Sheringham Shoal Extension and Dudgeon Extension Offshore Wind Farms

**Relevant Representations of Natural England**

Planning Inspectorate Reference: EN010109

14 November 2022

**Figure 3:** Amended extract of Figure 27.12.

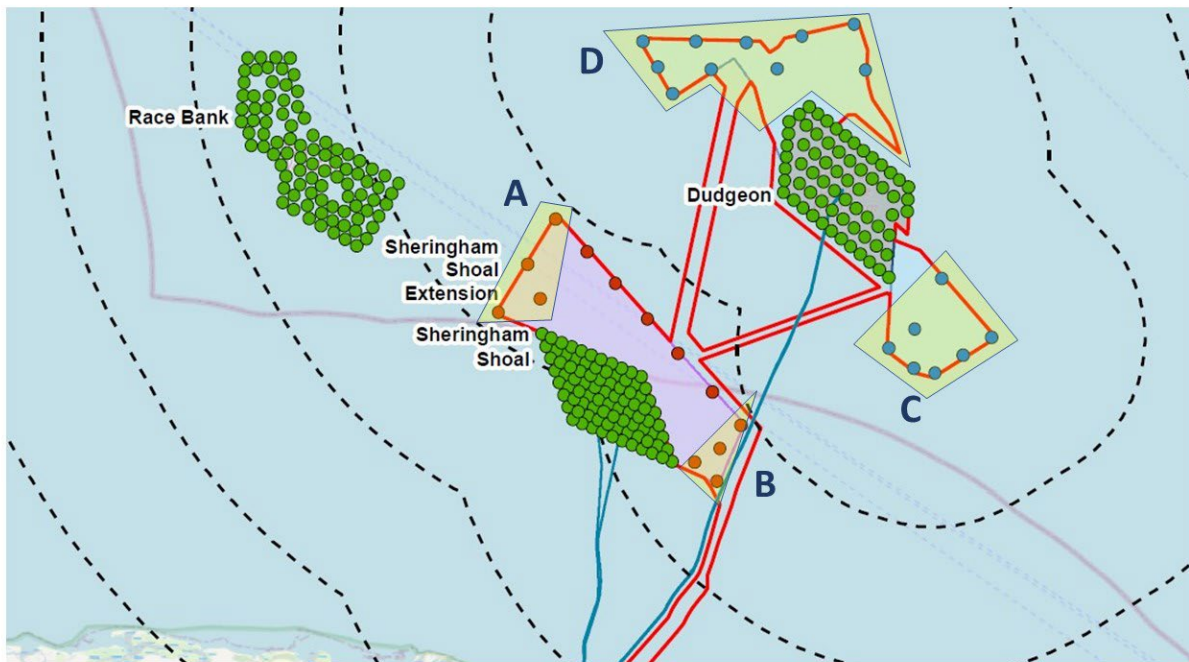
18. Whilst NE accepts the need to maximise the wind energy potential of these locations using the best available turbine technology, and for a design which is commercially viable, due to the significant difference in height between the existing arrays and the DEP / SEP schemes We would like to see further changes to the design of both DEP and SEP scheme in order that a high standard of Good Design, as required by EN-3 at paragraph 2.4.2, is achieved.

19. Following our review of the PEIR we offer the following observation on the design of the DEP and SEP arrays as set out in the PEIR.
  - Natural England judges that the turbines enclosed by boxes A, B and C are the prime cause of the adverse effects identified in the PEIR (Table 27-20, p.130). However, NE judges that these adverse effects are significant (in EIA terms) and will occur on multiple landscape and visual receptors located on the coastal edge of the NCAONB. As a result, **the statutory purpose of the NCAONB, and the special character of the NNHC, will be harmed.**

Figure 4: Light brown area highlights what is significant in EIA terms. See paragraph 73, p.42.

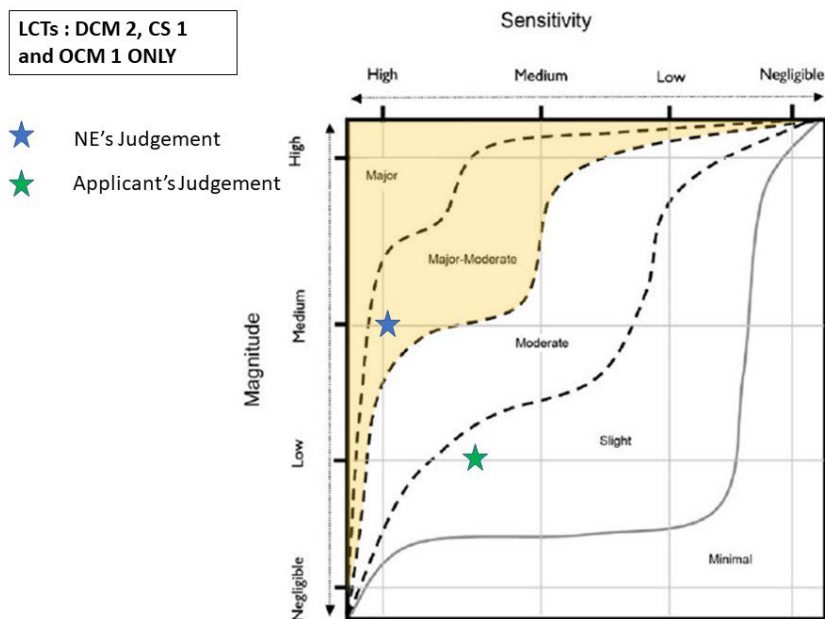
- iv. Significance of effect: combining these two judgements (for all 4 LCTs) results in a judgement of **Major-moderate** which is significant in EIA terms.

- v. The diagram below illustrates the difference between the Applicant's judgement and our own for LCTs OCM 1, DCM 2 and CS 1 only.

Figure 5: Light brown area highlights what is significant in EIA terms. See paragraph 73, p.42. As can be seen there is little between the Applicant's judgement and that of our own.

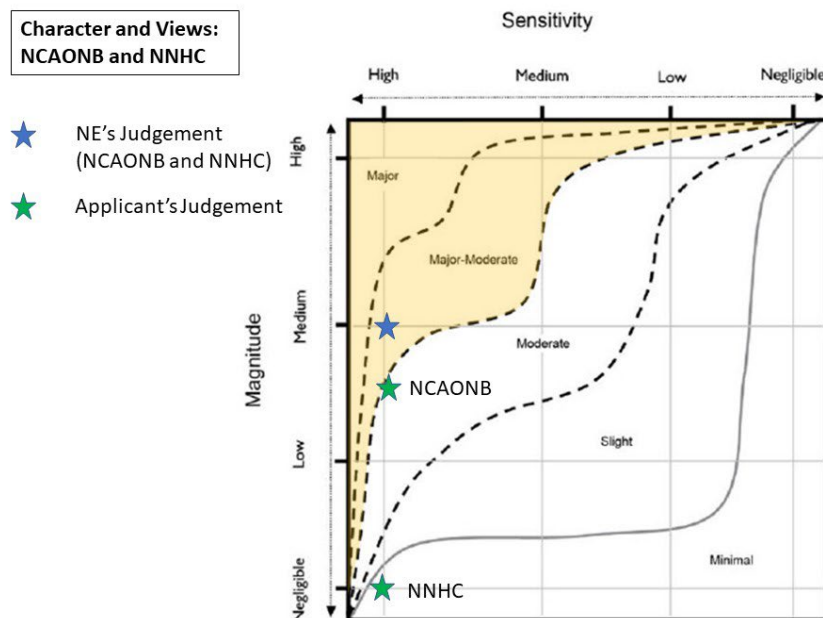
57. Natural England disagrees with the Applicant's judgement that effects on the Norfolk Coast AONB will not be significant. For the reasons already set out (see our comments for landscape and visual receptors) Natural England advises that the effect of the SEP scheme, and south-east portion of the DEP scheme (box C in the figure above), will have a significant adverse effect on the statutory purpose of the Norfolk Coast AONB. The assessment has also concluded that adverse effects (moderate) will occur on the 'character and views' (Table 27-20 p.131) of the NCAONB. As the diagram above illustrates there is in fact little difference between the Applicant's judgement and our own. We suggest this simply a matter of a difference in professional judgement and interpretation of the evidence.
